Architectural Review and
Historic Preservation Board
Agenda Report

File: AR 16-04

RE: Architectural Review 16-04 (Lydon Apartments) – 330 Cedar Street – Five Unit
Apartment Structure

SITE PLAN 1" = 20'-0"

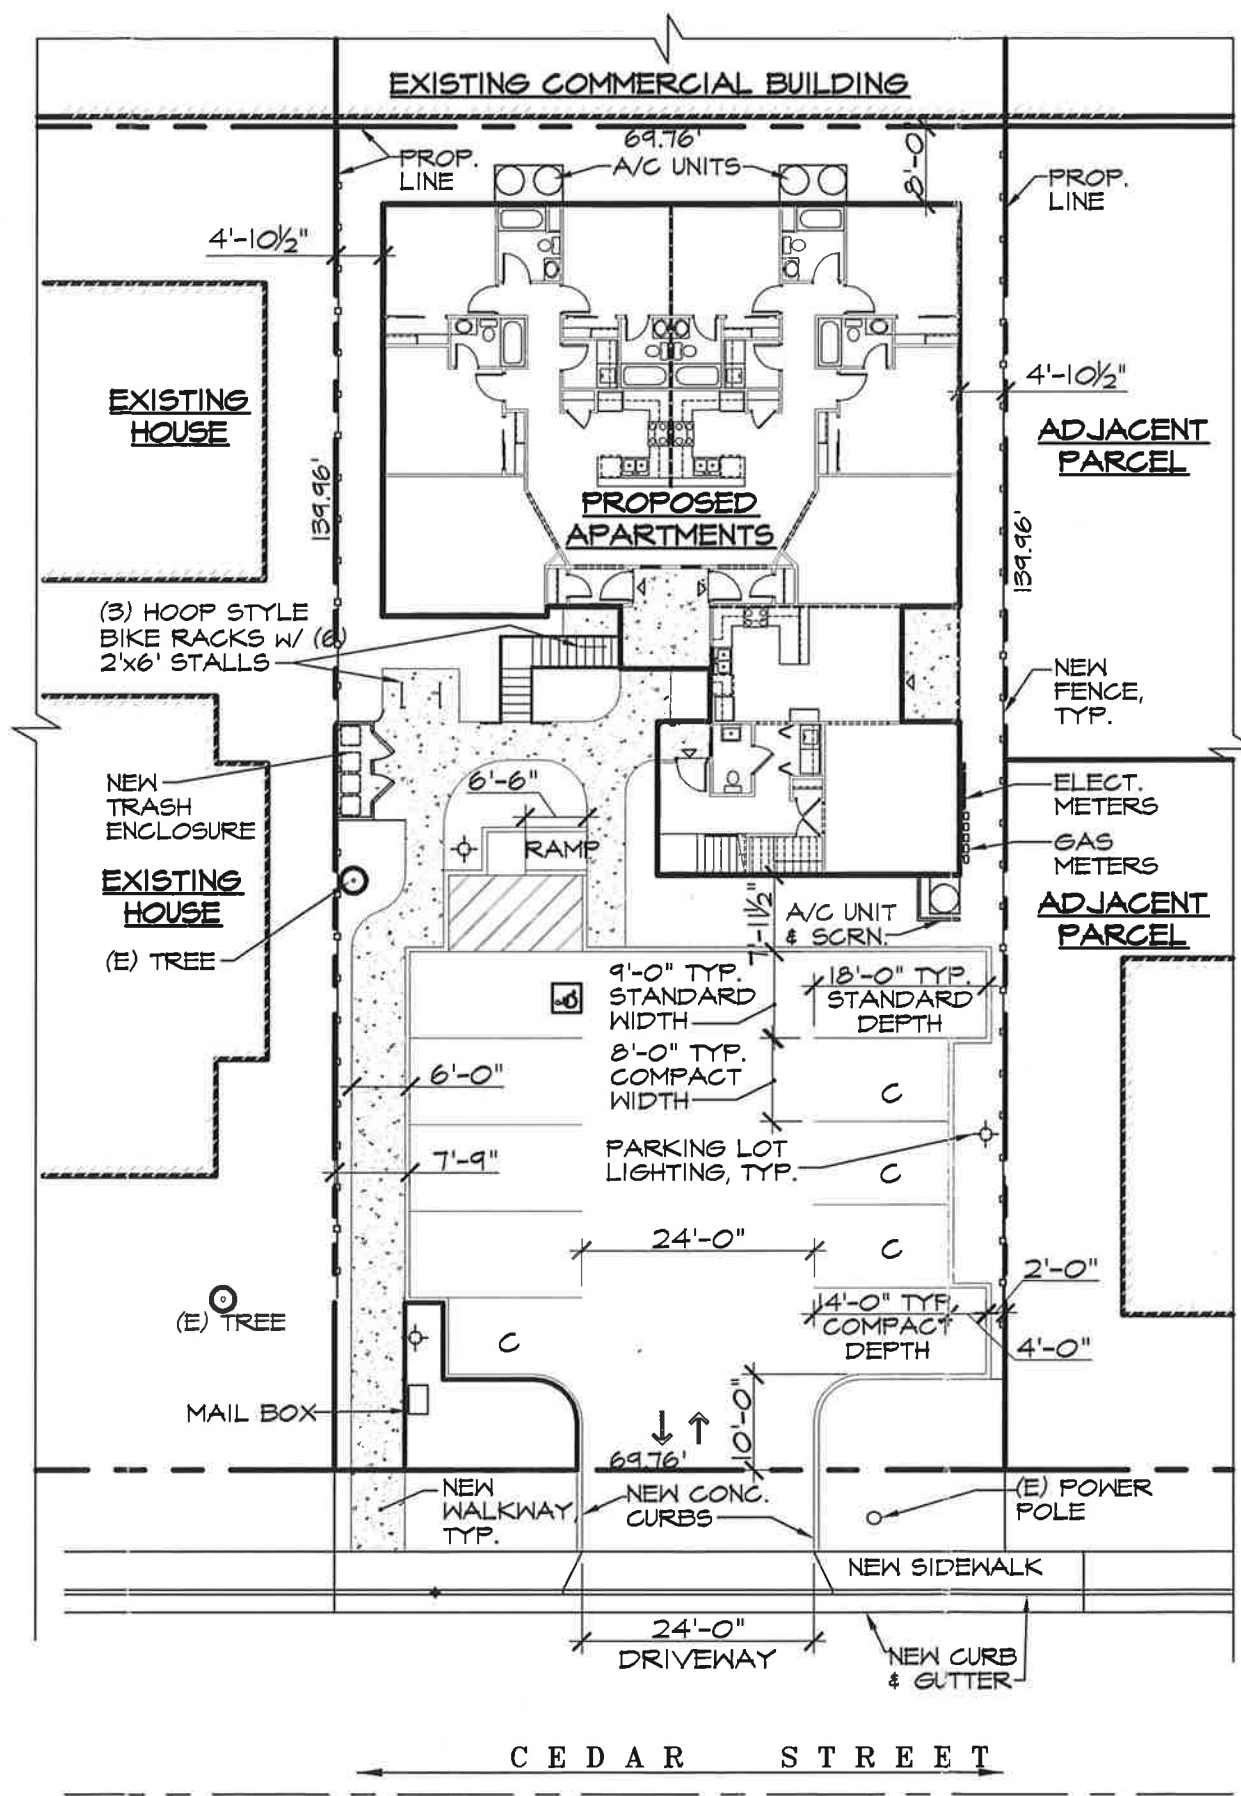
Vehicle parking stalls are placed at the front of the lot, with landscaping along the public right of way (see Landscape Plan, **Attachment F**). To screen the parking with a permanent feature such as a fence, staff recommends either relocating the trash enclosure away from the units to the mail box area, or provide a low wall. Such a condition would be consistent with the Design Guideline Manual (DG 3.1.24, 3.1.25) and the Chico Municipal Code (CMC) 19.70.060.B – *Design and development standards for off-street parking*, which requires parking lots to be screened. A series of low intensive bollards lights are proposed in the parking area (see Bollard Detail, **Attachment G**).

The Chico Municipal Code, supported by the Design Guideline Manual, require parking lots to be screened from the public right of way, by either shrubs, fences, mounds or a combination. Staff believes that the proposed trash enclosure near the apartments units would not be taken to the street by the tenants, and pose service issue to the trash haulers. Staff recommends that the enclosures be brought towards the street, and serve as both the enclosures, and screen the parking lot, and potentially have a sign or addressing. Thereby serving multiple purposes and meeting CMC requirements for parking lot screening.

ARB4

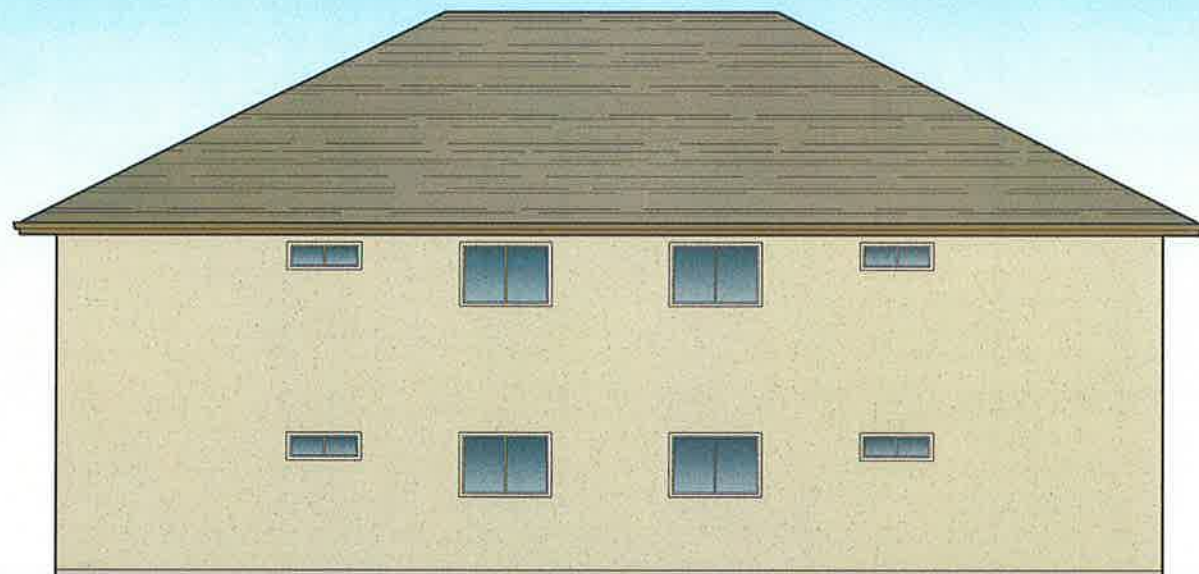
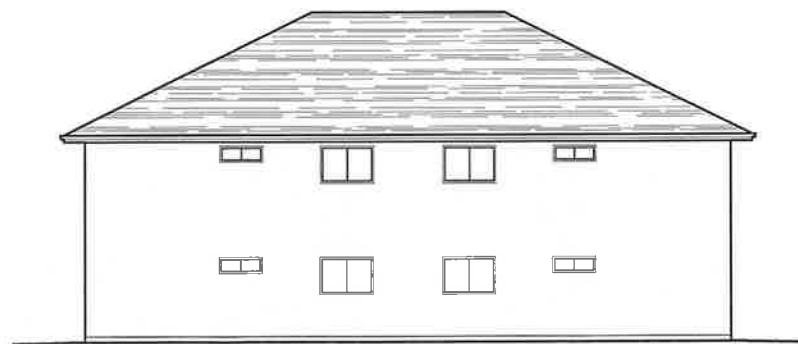
exception of one HVAC unit, which is screened by a low wall, all utilities are placed at the rear of the structure. Minimal details are presented on the rear elevation, but given that the structure backs up to an existing commercial center, which is built near the property line, staff does not anticipate that the rear of the structure would be highly visible. If the Board determines additional interest should be present on the rear elevation, staff recommends that the belly band extend around all elevations of the structure. Note that the gable details from the color elevation are different from the black and white elevation. Staff recommends that the Board confirm with the applicant which details are proposed.

Discuss gable details with applicant and confirm which elevation is correct and condition the project accordingly.

Sheet Title: **PLANTING PLAN**

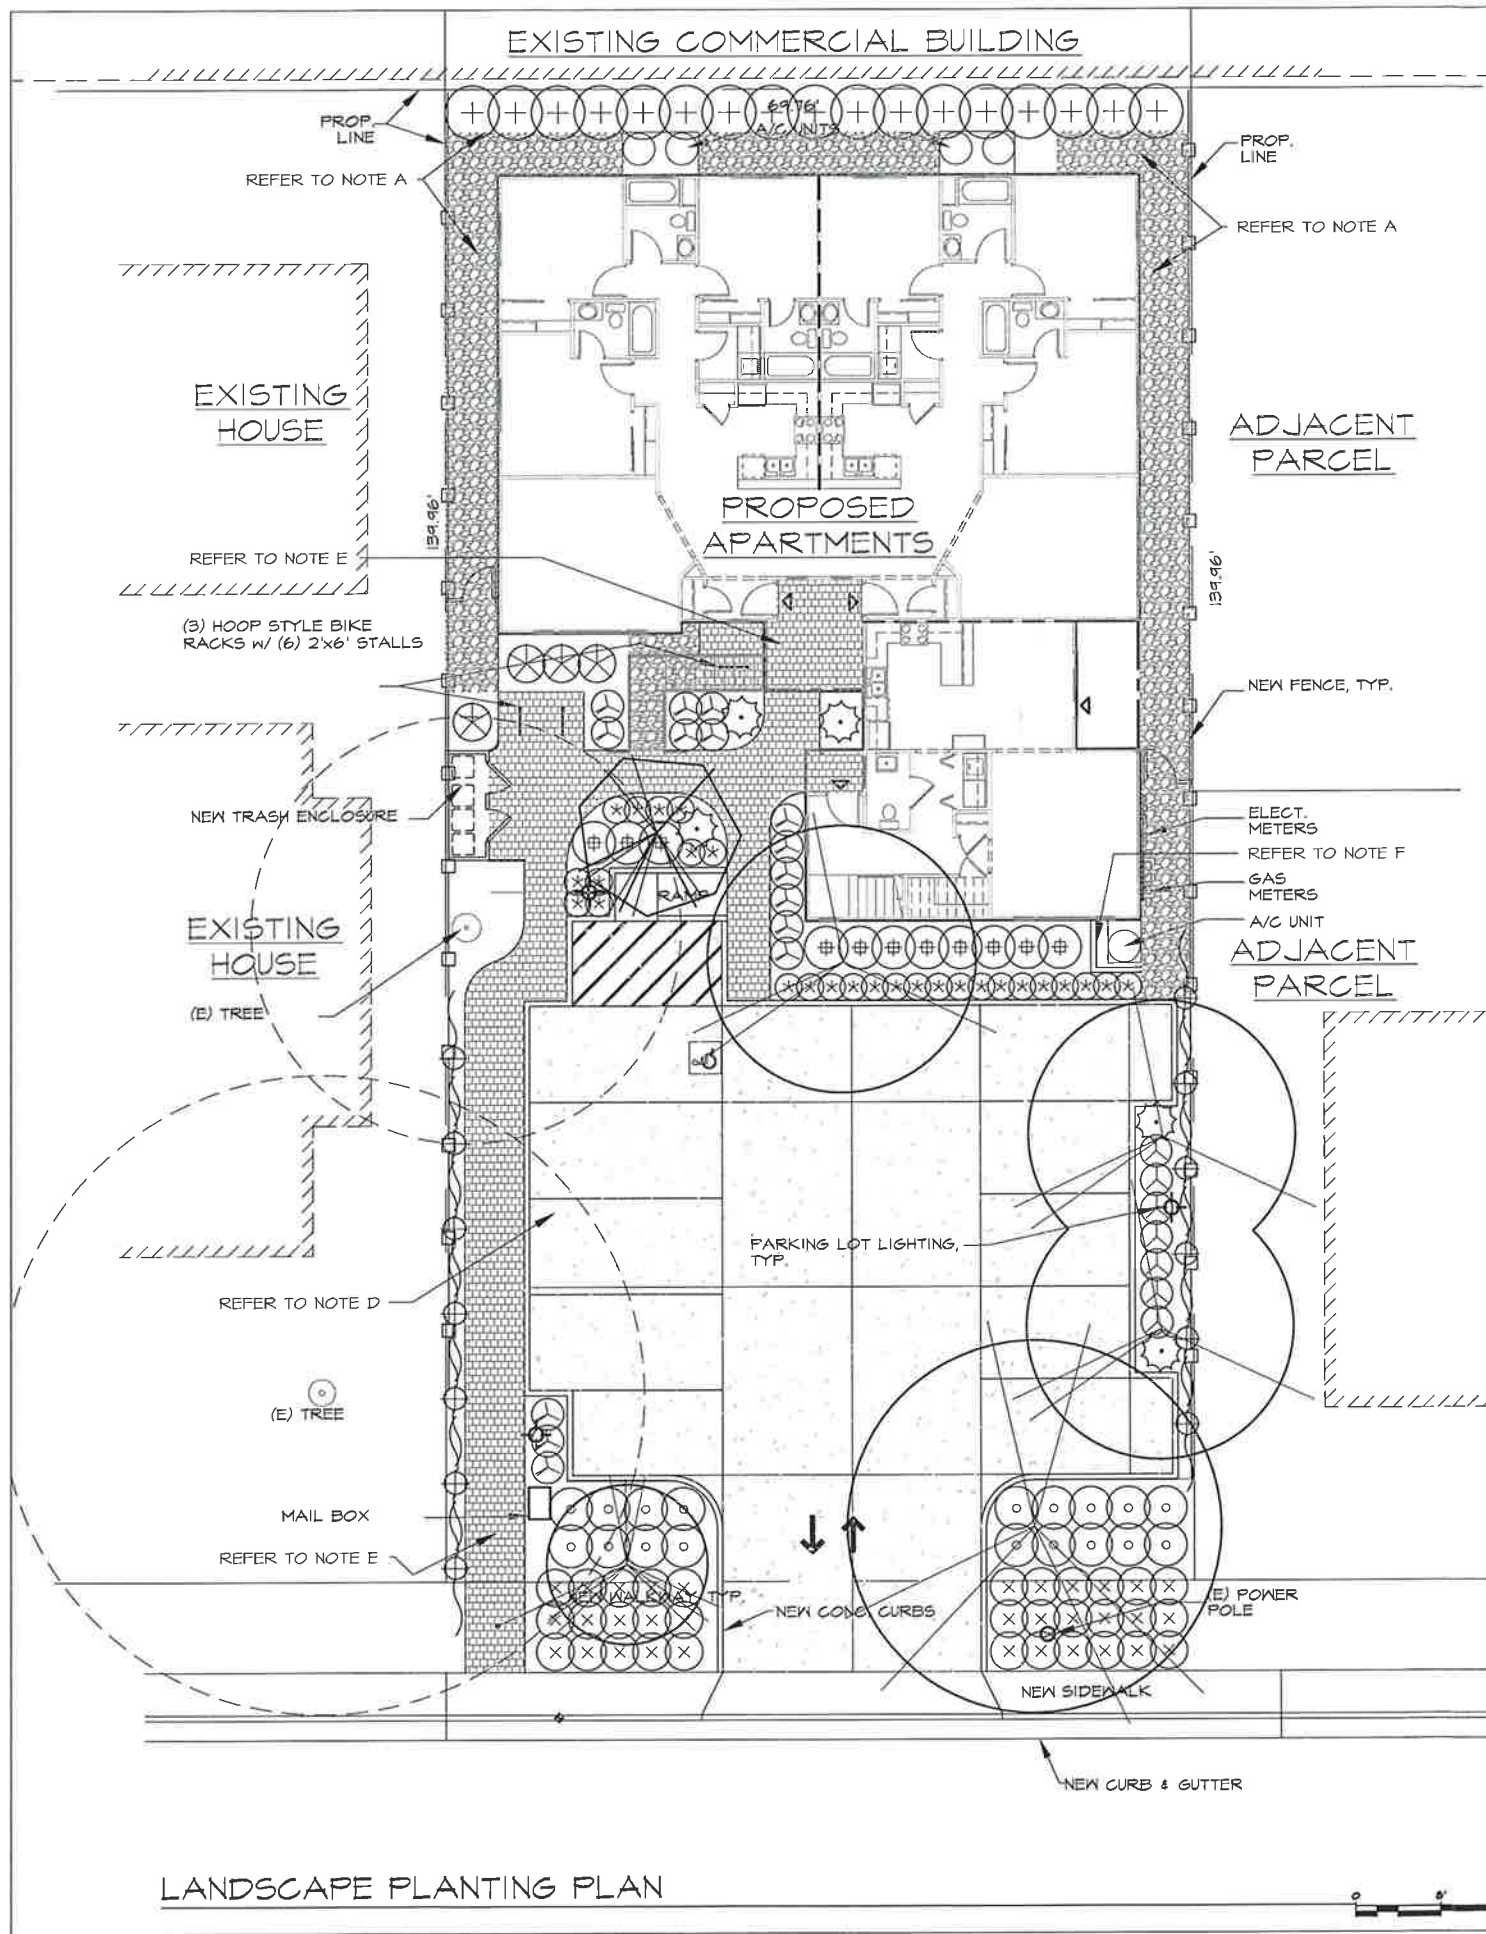
The landscape plans call for a variety of species with moderate to low water demands. A mixture of trees, shrubs, and perennials is proposed around the new buildings and throughout the new parking area to provide relief and add interest and color. Parking lot shading is estimated to reach approximately 67 percent at maturity, with Southern Magnolia and Red Sunset Maple trees. Additional accent trees are placed near the street frontage and by the structure.
